Washington Township Park Playground Equipment Removal & Disposal, Excavation, Surface Prep and Grade

Washington Township Park Addendum

ADDENDUM A

ADDENDUM B

NEW Playground Diagram (marked out on existing playground site)

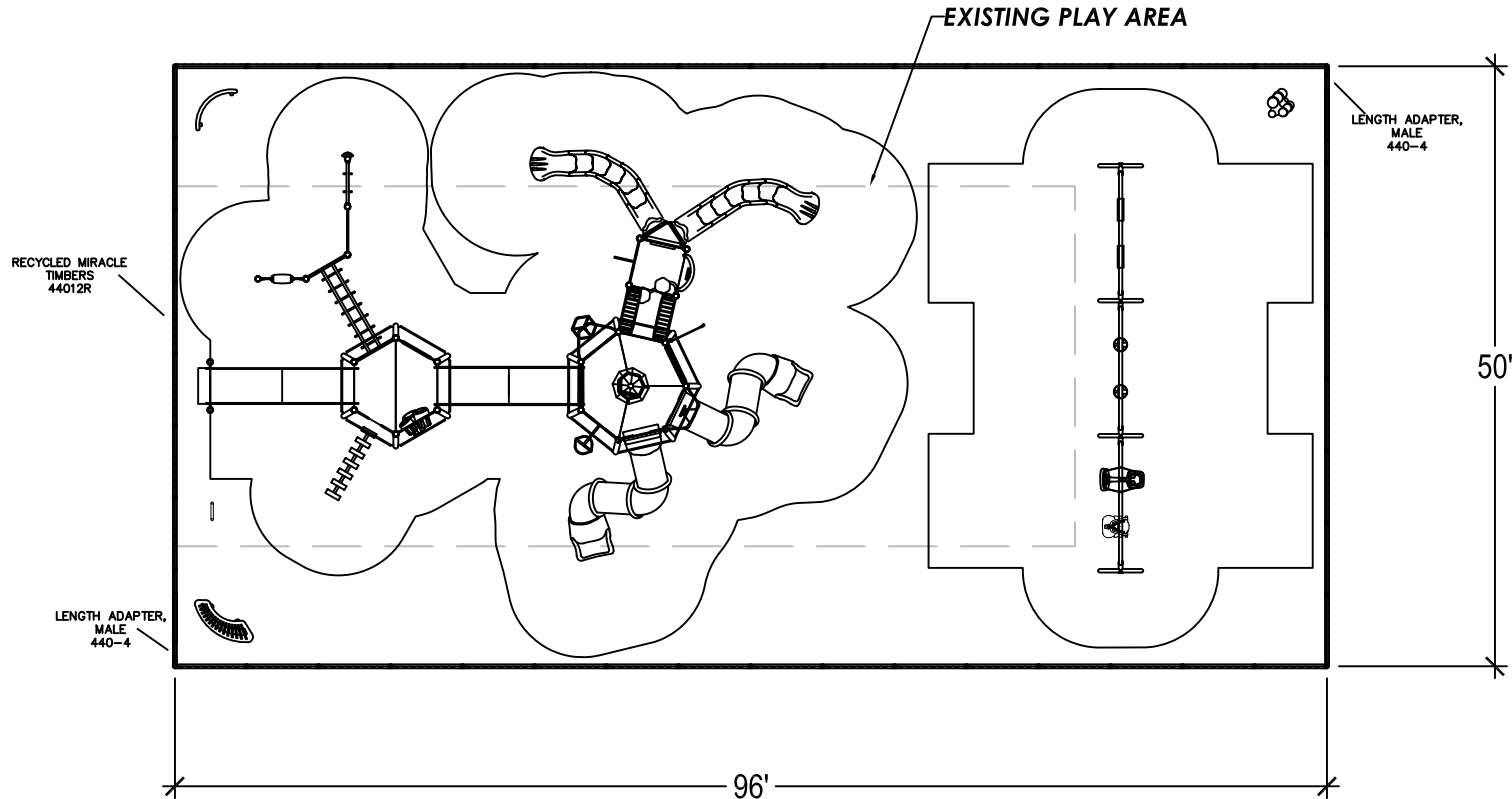
B1. 4% grade from 'X' on entry path to playground is is where grade

B2. BORDER of new playground area

Northside follow Northside of the asphalt entry path to playground

Southside follow line marked on grass in front of red maple tree

Westside follow tennis court fence post marked with green

Eastside line closest to soccer field.
